ENGINEERING CHANGE NOTICE NO.

05110

DWG NO. 647.7700

DWG TITLE: STRUT ASSY

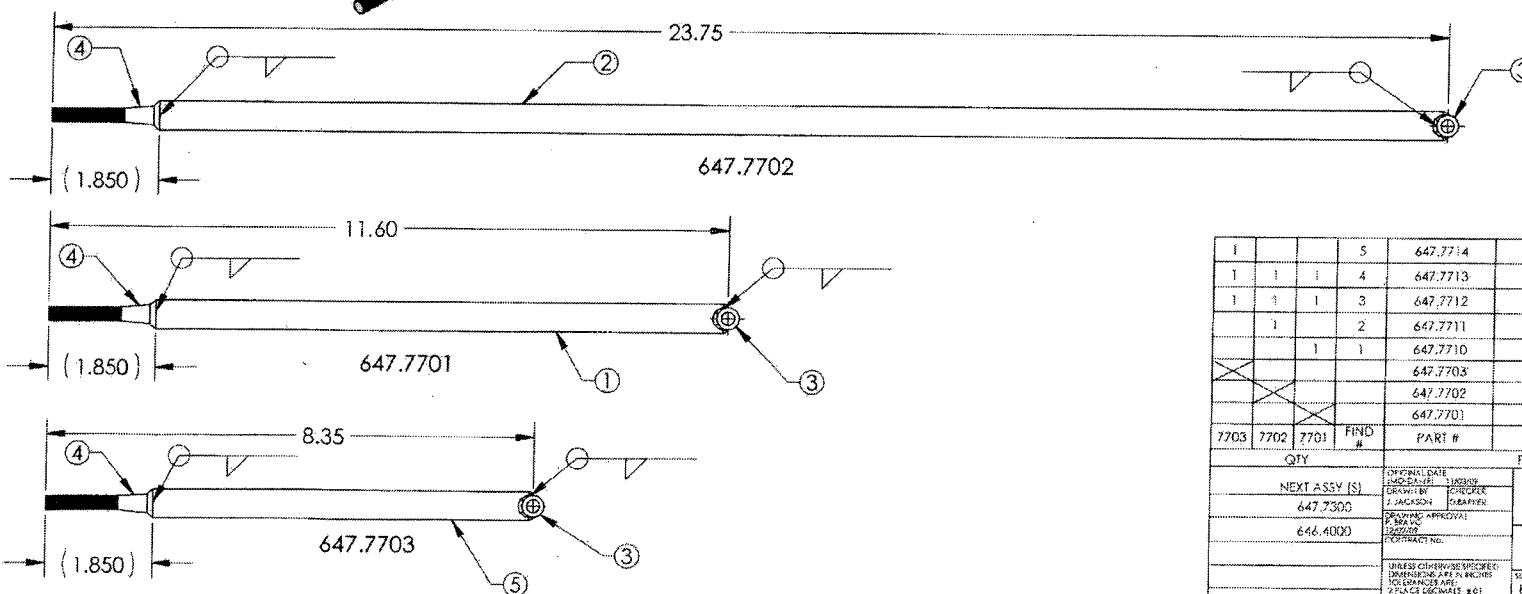
REASON: REVISED FINISH CALLOUT AS PER ECR 15-209

SHEET 1, NOTES IS:

- 1 MATERIAL: 4130 STEEL PER AMS-T-6736, .50" OD, .083" WALL THK.
- 2 MATERIAL: 4130 STEEL PER AMS-T-6736, .375" OD, .075" WALL THK.
- 3 MATERIAL: 4130 STEEL PER AMS-T-6736, .324" OD.
- 4 FINISH: PRIME IAW MIL-P-2337J TYPE I CLASS N; 1-2 MIL MAX
5. DEBURR AND BREAK ALL SHARP EDGES
6. IDENTIFY IAW MPP-120.
- 7 WELD IAW MIL-STD-2219, TIG WELD WITH FILLER ROD
- 8 FINISH: CAD PLATE IAW QQ-P-416F CLASS I TYPE II
- 9 MASK THREAD PRIOR TO FINISH

- 1 MATERIAL: 4130 STEEL PER AMS-T-6736, .50" OD, .083" WALL THK.
- 2 MATERIAL: 4130 STEEL PER AMS-T-6736, .375" OD, .075" WALL THK.
- 3 MATERIAL: 4130 STEEL PER AMS-T-6736, .324" OD.
- 4 FINISH: PRIME IAW MIL-P-2337 J TYPE I CLASS N: 1-2 MIL MAX
- 5 DEBURR AND BREAK ALL SHARP EDGES
- 6 IDENTIFY IAW MPP-120.
- 7 WELD IAW MIL-STD-2219, TIG WELD WITH FILLER ROD
- 8 FINISH: CAD PLATE IAW MIL-C-5541 CLASS 1A
- 9 MASK THREAD PRIOR TO FINISH
